Re: Conditional Approval, Amendment, Underground Waste Disposal
Site, Consolidation Coal Company, Emery Deep Mine,
ACT/015/015-88G, Folder #2, Emery County, Utah

RE: Review of Underground Waste Disposal Site, Consolidation Coal Company, Emery Deep Mine, ACT/015/015, Folder #2, Emery County, Utah

RE: Underground Development Waste Disposal, Consolidation
Coal Company, Emery Deep Mine, ACT/015/015-88G,
Folder #2, Emery County, Utah

RE: Deficiency Review Response, Underground Waste Disposal Site, Consolidation Coal Company, Emery Deep Mine, ACT/015/015-88G, Emery County Utah

EMERY DEEP WATER BUDGET

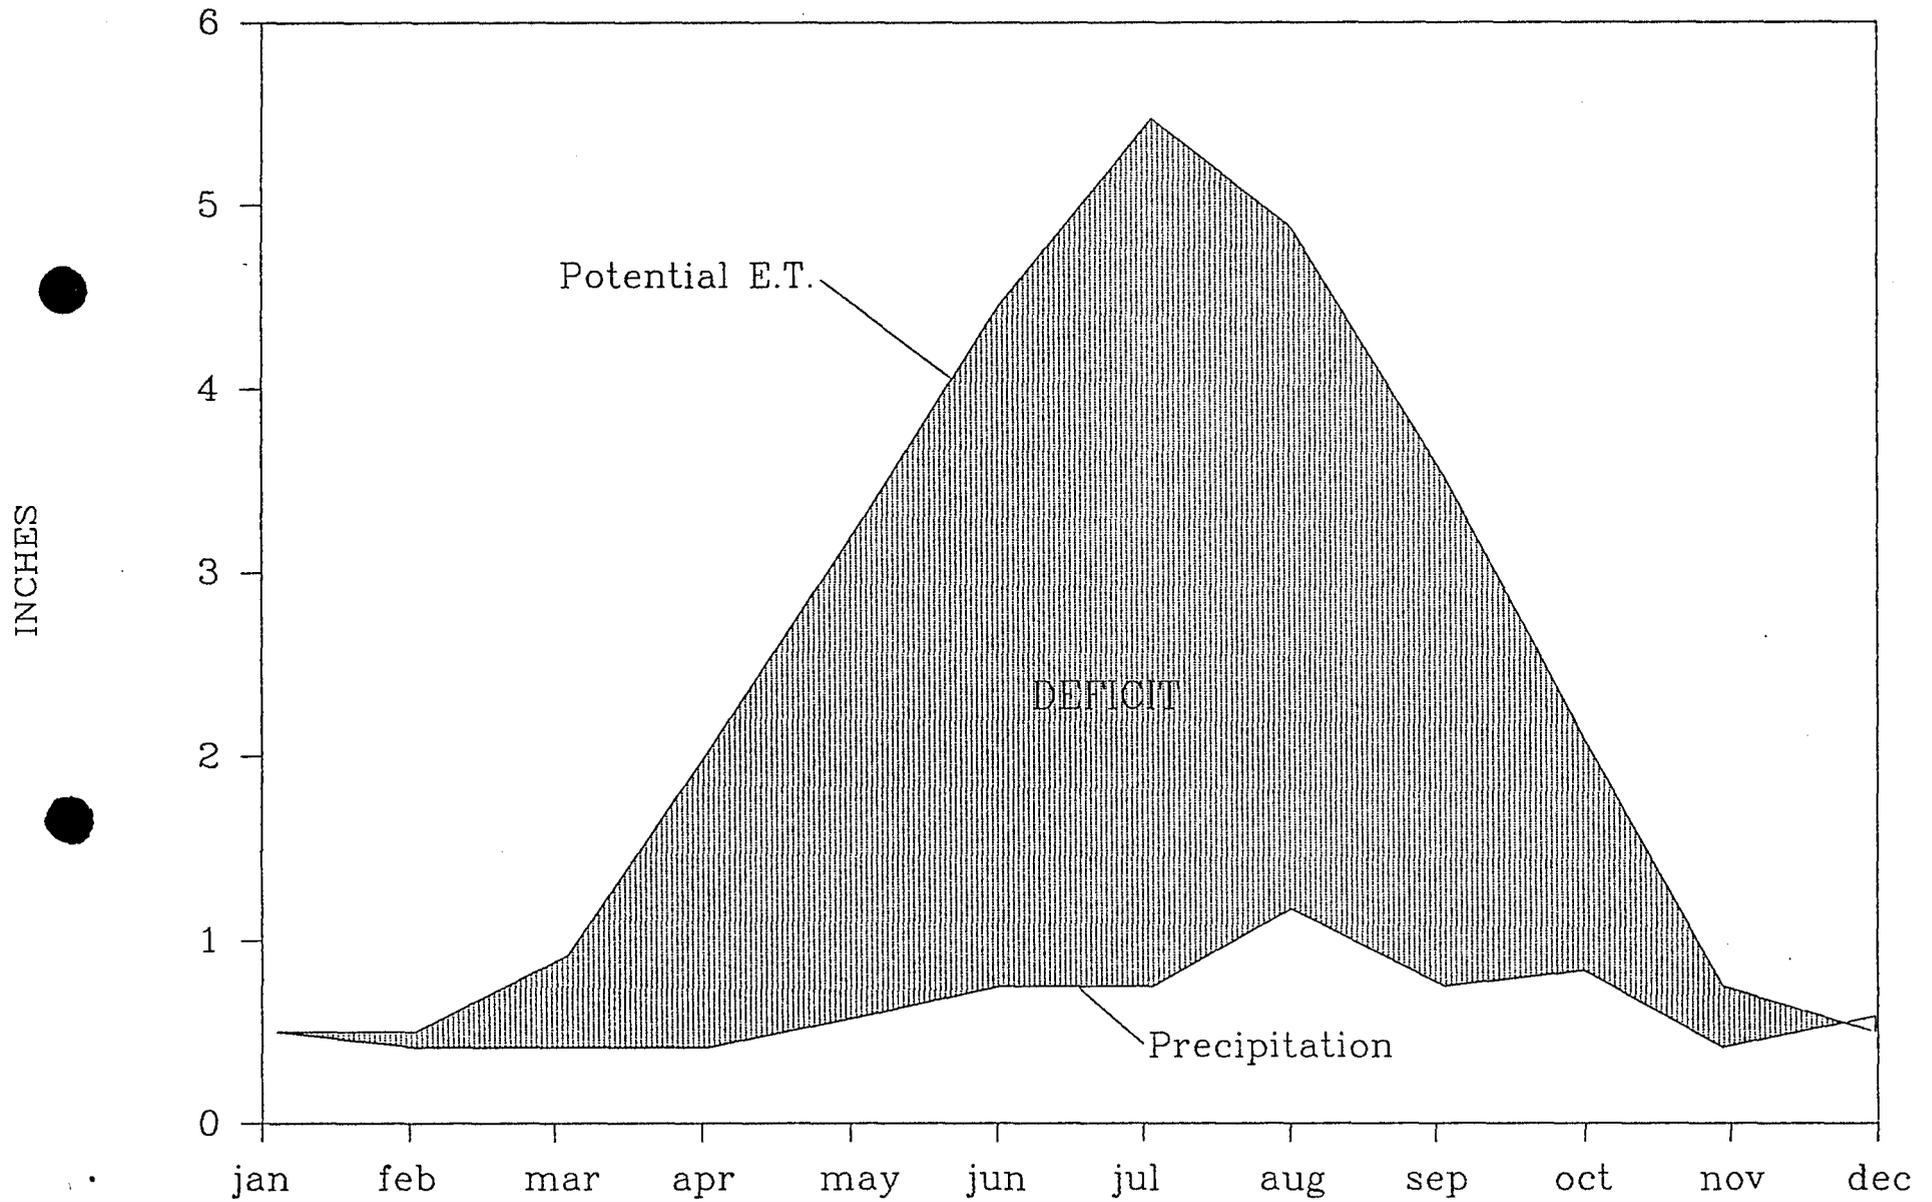
Page 13-85 of the submittal presents long term annual climatological data for the town of Emery, approximately four miles north of the mine site. This data is considered to be representative of conditions at the mine. A monthly water budget developed using this data exhibits a substantial moisture deficit essentially throughout the entire year (see attached figure).
